**Town of Hinesburg
Planning Commission
November 28, 2018
Approved December 12, 2018**

Official Map Revisions:

Hinesburg Official Map
DRAFT REVISIONS

DRAFT 5
(for community input)

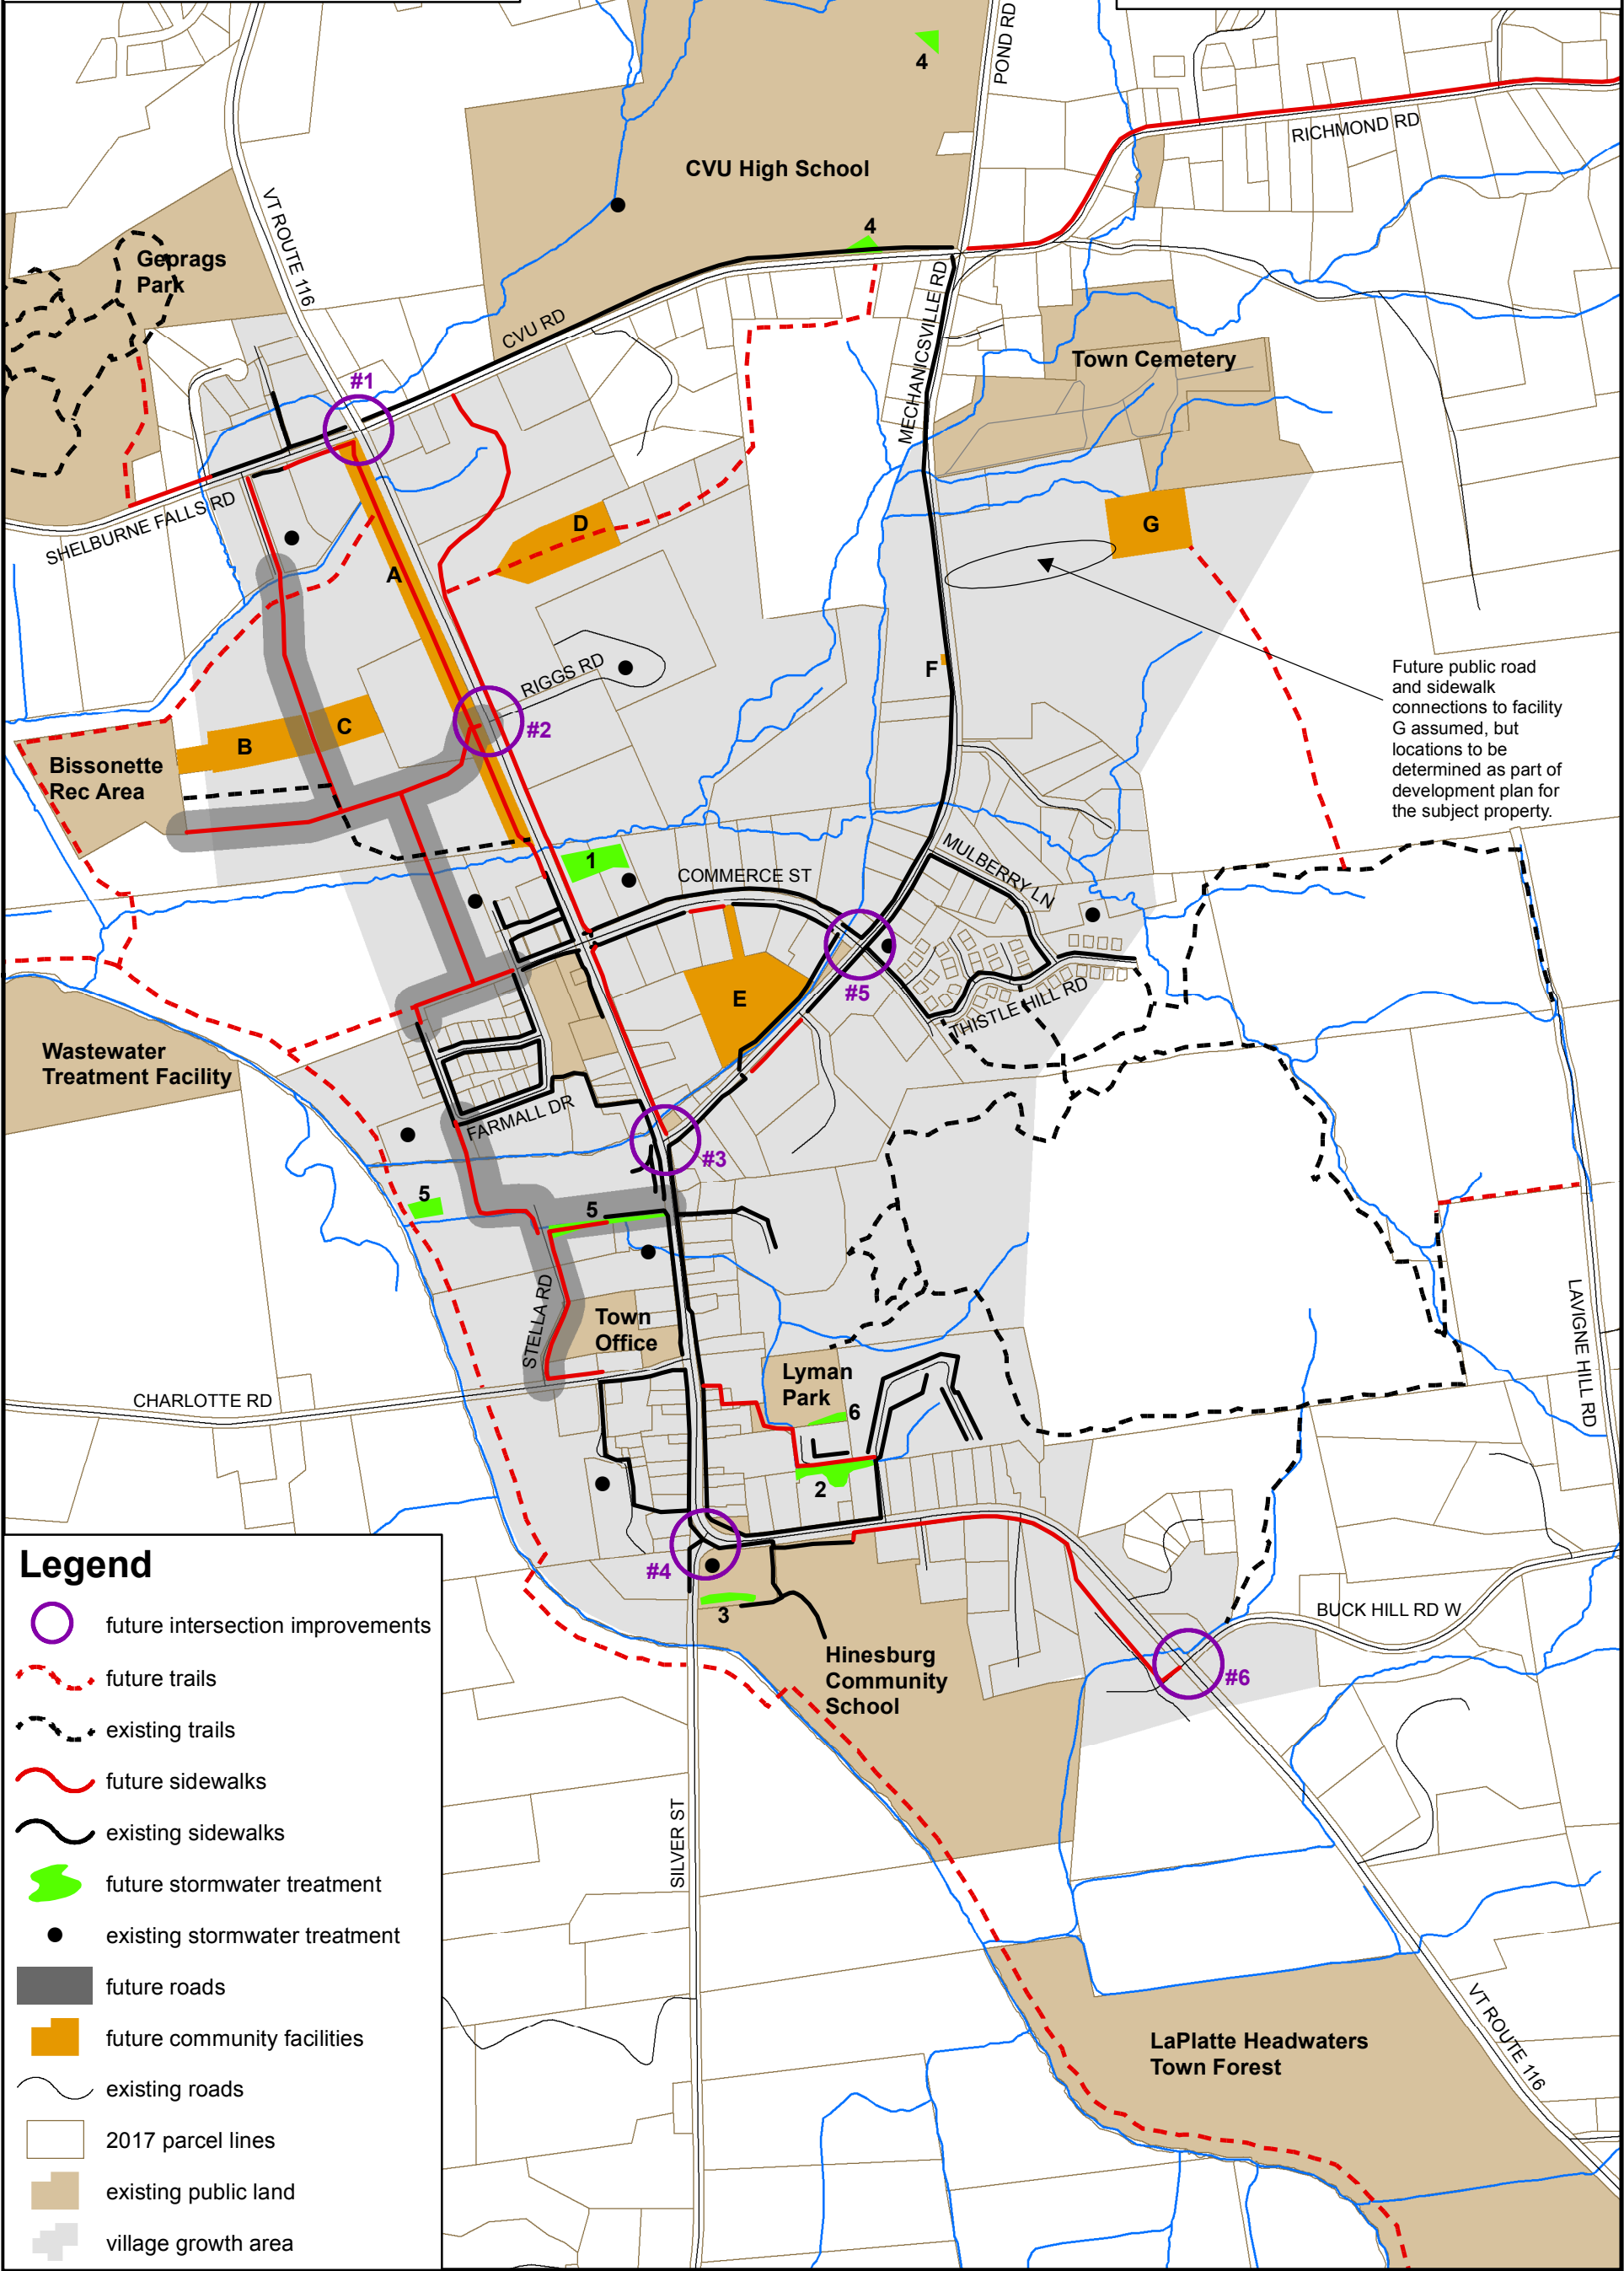
Rolf K. summarized his comments, which were that we could be sympathetic to Creekside residents' apprehension about the road connection from Charlotte Rd to Shelburne Falls Rd. We often assume that larger urban areas have problems that don't come to us. A bypass road near where he grew up was originally 2-lane, now 20-lane, and is always full. Is this what we want to be doing? He also commented on the fact that this is prioritizing movement by automobile. How do we proactively change this trend? Let's think about not facilitating the movement of cars; perhaps traffic jams are exactly what we need.

Kyle B. asked about the Shelburne-Charlotte Rd. connection: we want connectivity but not the easiest path – trees, curbs, stop signs, one-ways, etc. should be prevalent. He felt the Creekside street should have been made wider. Joe I. pointed out that at the time we had no Official Map. Rolf K. asked, and Alex W. replied they are 24' wide. Kyle B. pointed out that with people parking on each side of the street, you are essentially blocking the street. Alex W. said they would be wider if there was designated on-street parking (but there is not).

John K. confirmed that if you build a road, it will draw traffic, not relieve traffic effectively. He added that networks are important, but not straight shots through neighborhoods. We already have several turns to make; perhaps we could have the leg only going to east (not west from Creekside). Maybe a connection continued from behind fire station? Also, landscaping and stop signs, narrow spots, speed bumps. Alex W. clarified what area John K. was pointing out; Joe I. and Kyle B. felt you would just be moving traffic from one area of the neighborhood to another.

James D. suggested a connection from behind the storage facility to the area where Hinesburgh Public House employees park, then around the Cheeseplant parking area out to Stella Rd. It may be an asset for storage facility, as well as the Cheeseplant property. Alex W. suggested it would be problematic to get across the canal there (which is deep there), and getting through tight areas between buildings. In addition, the town already owns the area west of the Cheeseplant, and the connection to Farmall. The commission asked about the area south of Creekside (is it wet)? The association of four houses in Creekside owns all the way down to the brook there.

Joe I. said it is important to reserve some right of way, whether vehicular or not. Hopefully northern and southern sections of this connection are less controversial. Alex W. said it is important to have the Cheeseplant on the official map, so if they develop further, they would need to accommodate road and sidewalk. Joe I. suggested any road connections be required to be pedestrian friendly with queues for traffic. Perhaps using wording that would reserve the space for road + sidewalk, but also allow it to be just pedestrian or one-way traffic would be useful.

Rolf K. said we don't want this to get lost. That neighborhood will always be vocal about what moves through there. Alex W. said if they want to keep the road, the easiest way to address it is to use a letter or note that clarifies what is and what it is not supposed to be. Joe I. said this is important along whole corridor, and others agreed. All agreed it was not supposed to be a highway. John K. suggested using some notation (like the numbered intersections) to note other things – lighting, crosswalks, etc. Alex W. said it is particularly important at this location due to through traffic, etc.

Joe I. suggested we annotate these roads and list what the expectations are for the connection. He would suggest breaking it up into 3 or 4 sections. Most will be sinuous, traffic-calming, pedestrian friendly. Most segments suggested for pedestrian and vehicle. From Commerce to Cheeseplant, it could be both or just pedestrian. John K. would also like to clarify the segments from east-west to Rec Fields. Alex W. said he'd be happy to take a crack at it. Alex W. asked Kyle B. what he thought about this approach. Kyle B. said he would personally not like to see the road at all, but he will agree to it for the greater good; but if you make it easy it will become a high-speed bypass with rolling stops through a residential neighborhood. He'd like to see it made difficult/unappealing to get through. John K. said we have two watercourses to cross. Alex W. said there are data about these crossings; it would be a 7' box culvert to cross Patrick Brook based on modeling, he would assume similar but smaller to cross canal. Joe I. asked about the culvert under Route 116; Alex W. said it is somewhat undersized (7' instead of 8').

John K. asked why gray markings don't continue all the way to Shelburne Falls Rd. Alex W. said it is because it is already built. John K. said the property to the west is not developed yet, so we could extend the gray markings to Shelburne Falls Rd. so we could specify landscaping, traffic calming, etc. Alex W. said he could extend it, but would then also recommend extending it through Creekside. He didn't want to give property owners the wrong idea (that the town would like to buy the property if they develop it). Joe I. said it is better to be specific. Alex W. suggested he could add a special segment to these already-developed areas to clarify.

Kyle B. asked for a summary of changes they would see based on public comment. Alex W. replied he will make some changes to the map based on the Commission's feedback at last meeting (in Nov. 14 meeting minutes). This is the fourth meeting they've been discussing and ready to receive public comment. They've received comments from Peter Erb, Lenore Budd, Nathan Fry, Ute Talley, and Teresa Celemin. Kyle B. asked if they will be reflected in changes. Alex W. said Lenore's would, Teresa's would not, Peter Erb's may still be in play, Nathan Fry's comments were re: green space, Ute Talley's comments re: road are on the docket for tonight. John K. mentioned that there were other comments received during the Oct. 24 meeting from Kate Webster re: road connection.
